LVD Timing Diagram Correction

SPI-3R7 Figure 44 & 45 correction

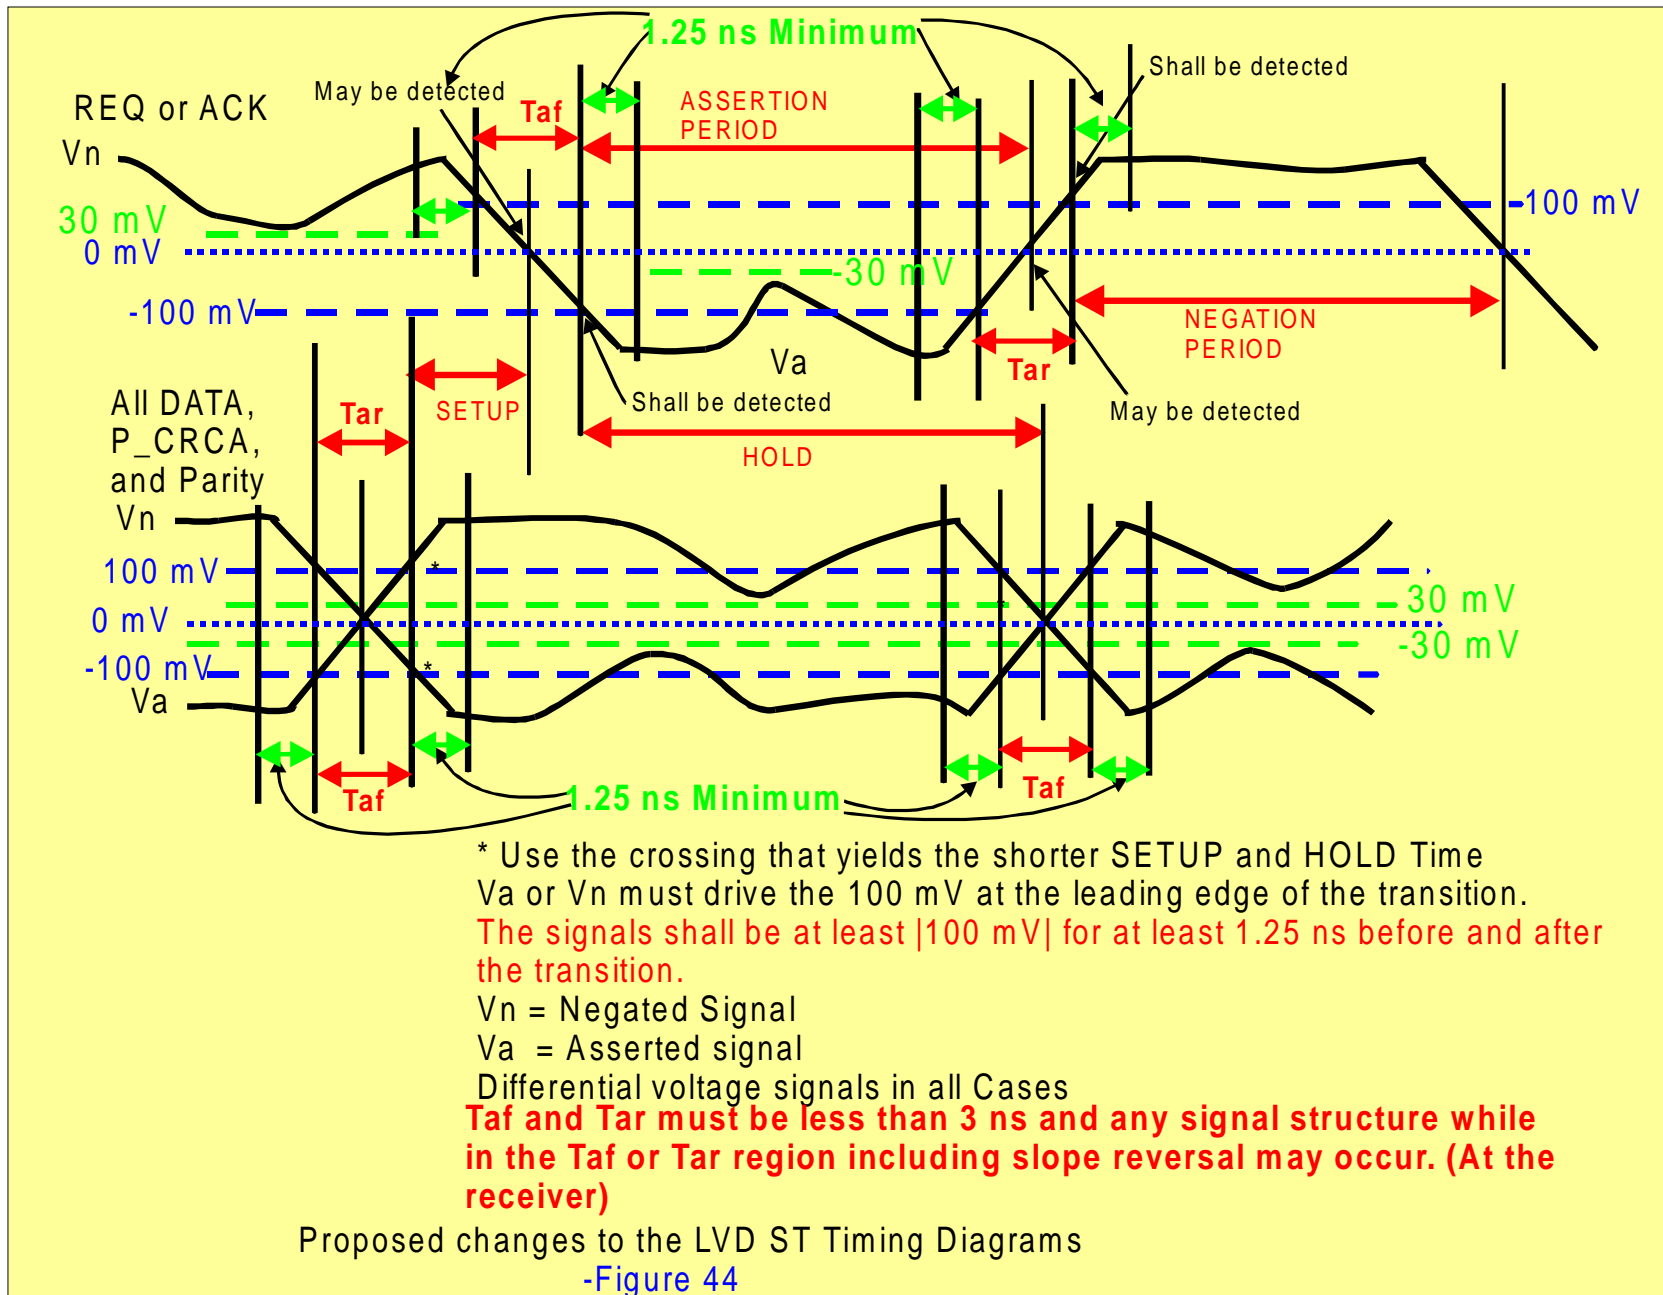
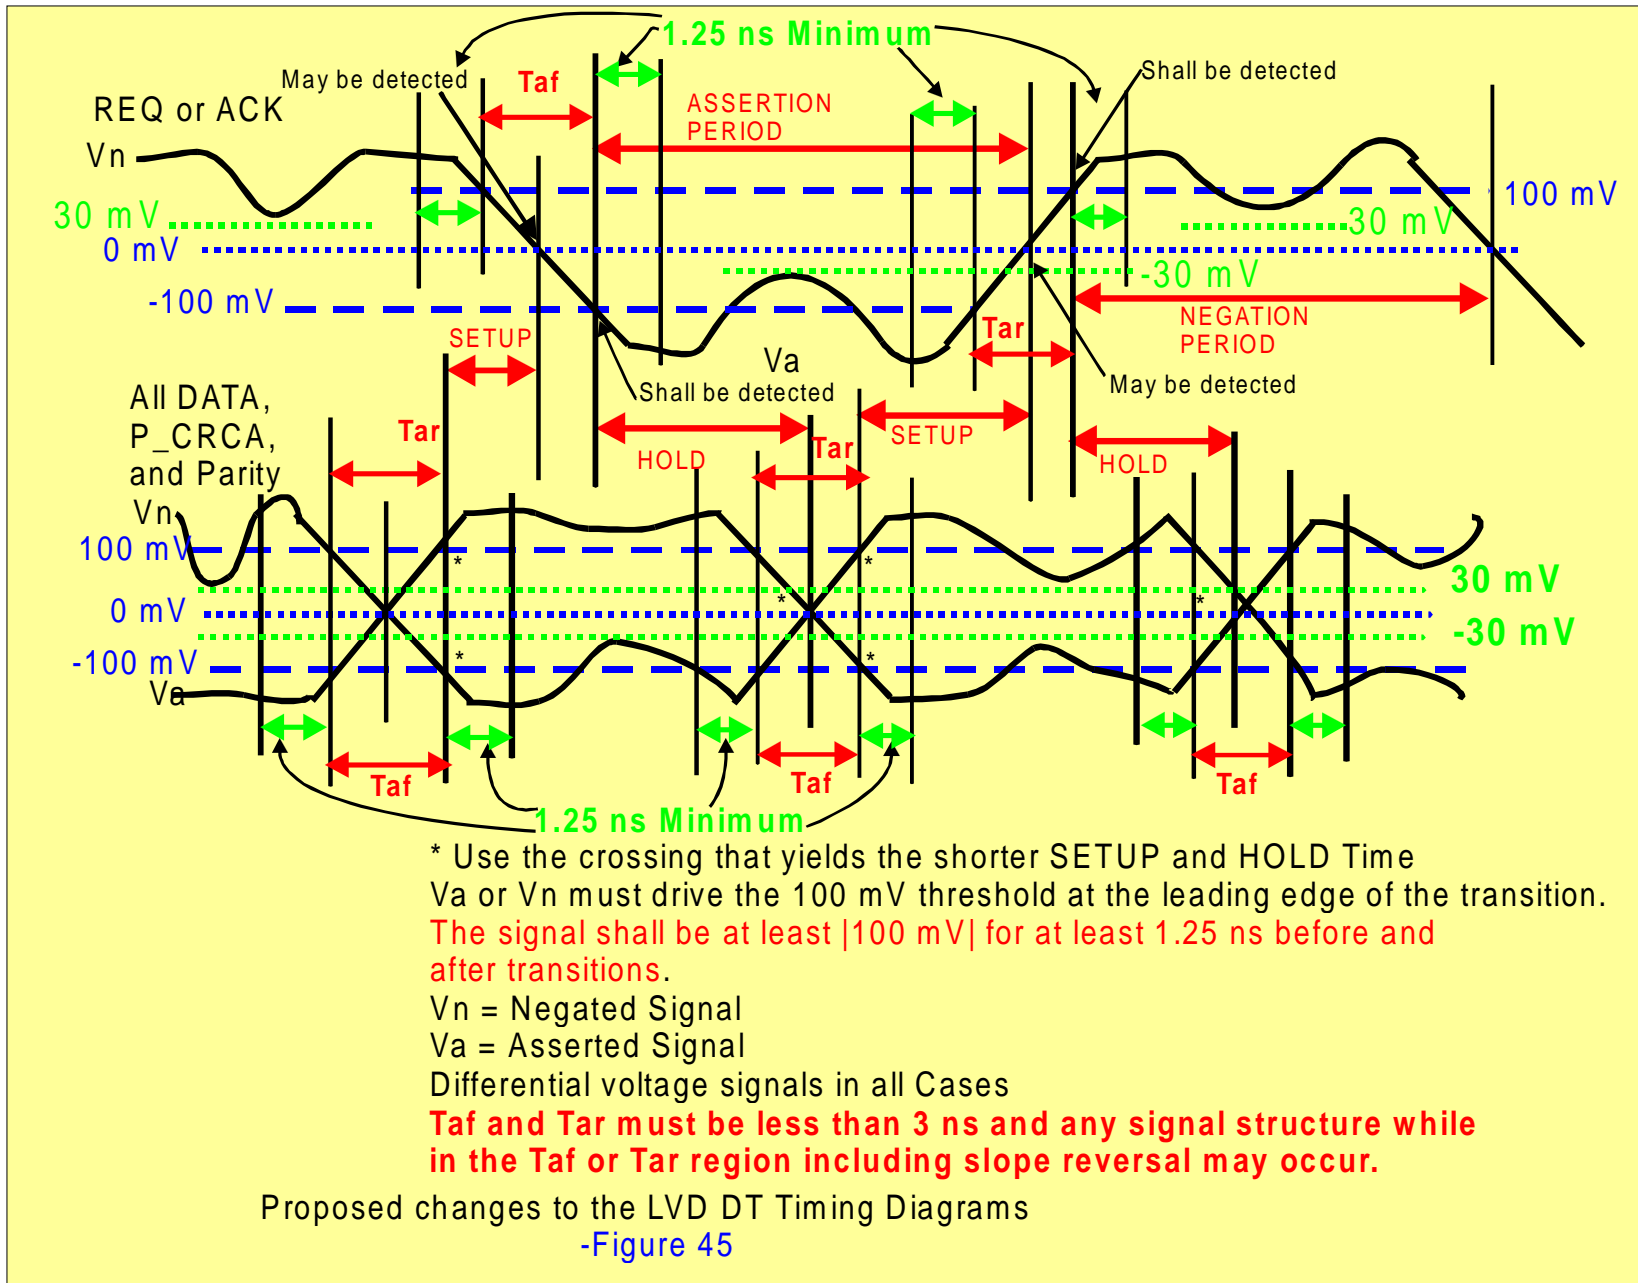
Text Correction

- 9.3.3 LVD Transfer Rates second paragraph Text Correction
- Figure 44 and figure 45 illustrates the signal must transition from -100 to 100 mV or 100 to - 100 mV in 3 ns, the waveform between -100 and 100 mV is not otherwise specified. Signals shall remain above the |100 mV| level for 1.25 ns at each end of the transition. The signals shall not drop below |30 mV| except during the transitions. Conditions exist with longer loaded SCSI busses and irregular REQ and ACK pulse widths where long assertions or negations produce a much larger signal than short assertions or negations. This sets up an environment where the short REQ or ACK pulses may not have adequate timing margin unless the definitions in figure 44 and 45 are used in the measurement of timing parameters.

Note: Blue is delete, red is add

Receiver Mask, during the data transitions
 +/-1.1 volt maximum with reflections

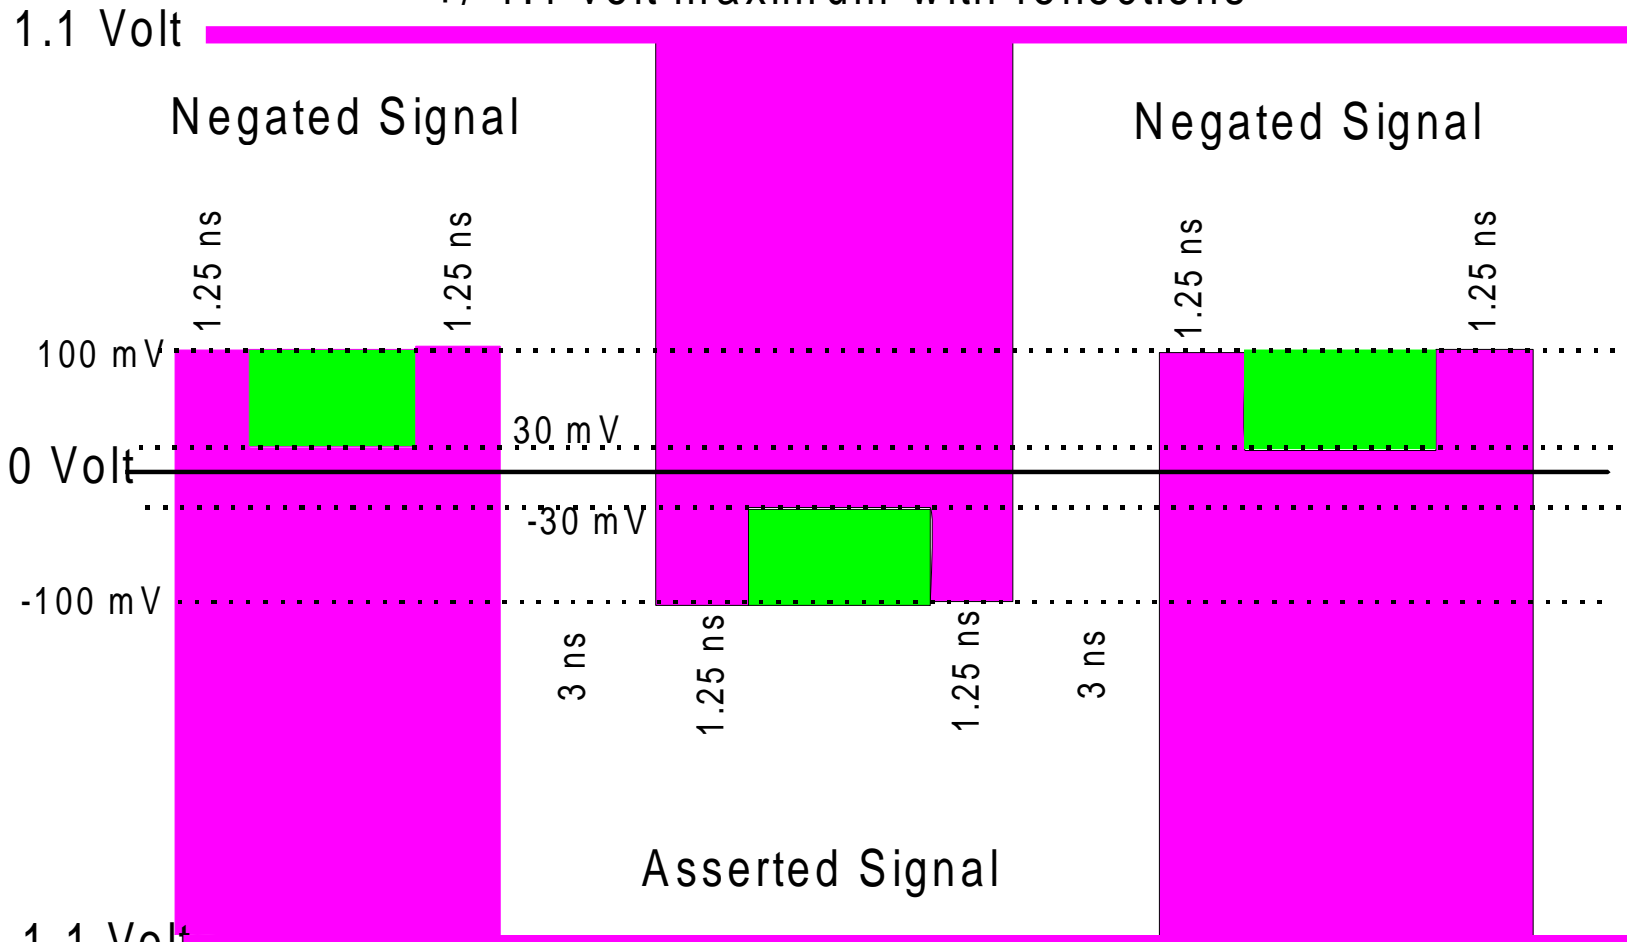
Receiver Mask

- Add a receiver mask for the allowable signal at the Receiving device connector.
 - Edges of transitions are require at least $|100 \text{ mV}|$ for 1.25 ns.
 - Signals are allowed to have noise inside the assertion or negation signal that drop back to $|30 \text{ mV}|$.

The ratio of the Peak before the transition to the Peak after the transition in the 1.25 ns range shall not exceed 4 to 1.
